Complaint - Check Engine Error Message in Conjunction with Loss of Power or a Creaking Noise after Switching off the Engine (222/20)

Model Line: **Cayman (982)/Cayman S (982)/Cayman GTS (982)/Cayman T (982)**

Concerns: **Boost pressure control cycle valve**

Installation position of Boost pressure control cycle valve

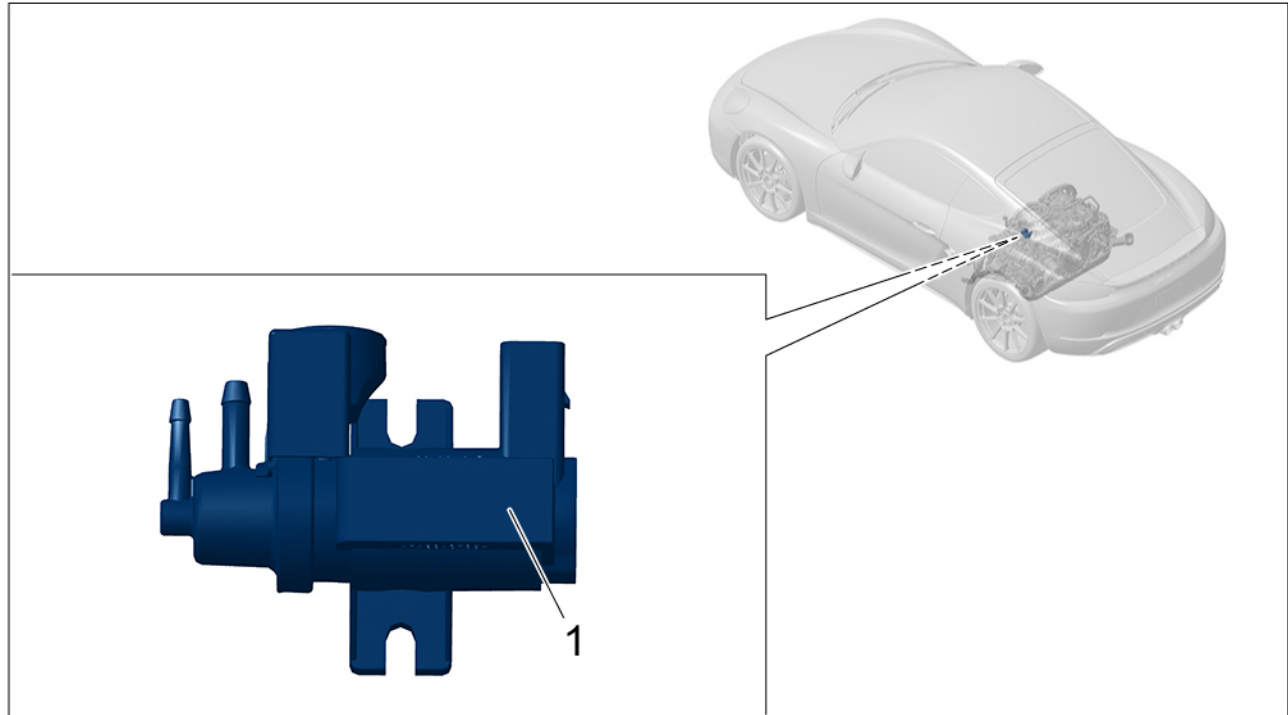
Date of Introduction: A Boost pressure control cycle valve with an external air cleaner has been installed during production since December 10, 2020.

Action required: Remove old Boost pressure control cycle valve and install new Boost pressure control cycle valve with external air cleaner.

Boost pressure control cycle valve (new)

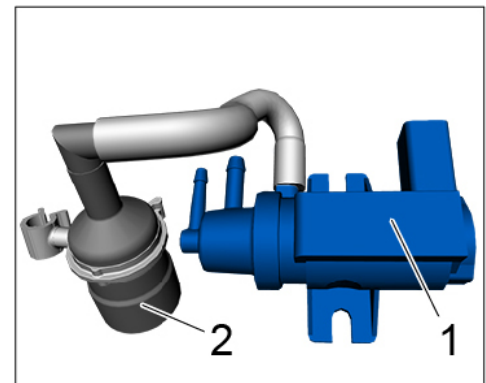
- 2 Prepare new Boost pressure control cycle valve for installing.
- To do this, install air cleaner ⇒ *Boost pressure control cycle valve (new) -2-* as shown ⇒ *Boost pressure control cycle valve (new)* on the Boost pressure control cycle valve ⇒ *Boost pressure control cycle valve (new) -1-*.

Boost pressure control cycle valve for turbocharger (new)

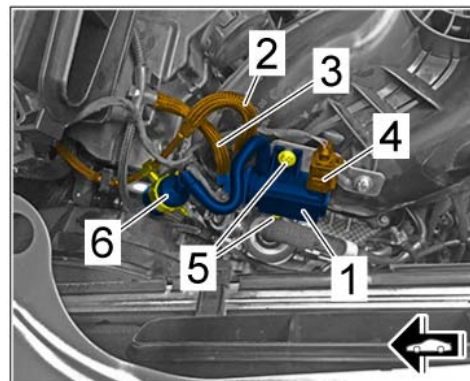
- 3 Install new Boost pressure control cycle valve with external air cleaner.
 - 3.1 Position new Boost pressure control cycle valve ⇒ *Boost pressure control cycle valve for turbocharger (new)-1-* and install and tighten fastening screws ⇒ *Boost pressure control cycle valve for turbocharger (new)-5-*.
Tightening torque 13 Nm (9.5 ftlb.)
 - 3.2 Position and connect vacuum hoses ⇒ *Boost pressure control cycle valve for turbocharger (new)-2-* and ⇒ *Boost pressure control cycle valve for turbocharger (new)-3-* on the Boost pressure control cycle valve ⇒ *Boost pressure control cycle valve for turbocharger (new)-1-* one after the other.

- 3.3 Connect and lock electric plug connection ⇒ *Boost pressure control cycle valve for turbocharger (new)-4-*.

- 3.4 Clip in combination holder ⇒ *Boost pressure control cycle valve for turbocharger (new)* -6- on the vacuum hose ⇒ *Boost pressure control cycle valve for turbocharger (new)* -2- underneath the anti-chafing tape.

Once installed, check the routing and position of the vacuum hoses with regard to the following points and re-position them if necessary.

- Sufficient distance from heat shields/fan housing/electric plug connection for high-pressure pump
- Vacuum hoses are not strained
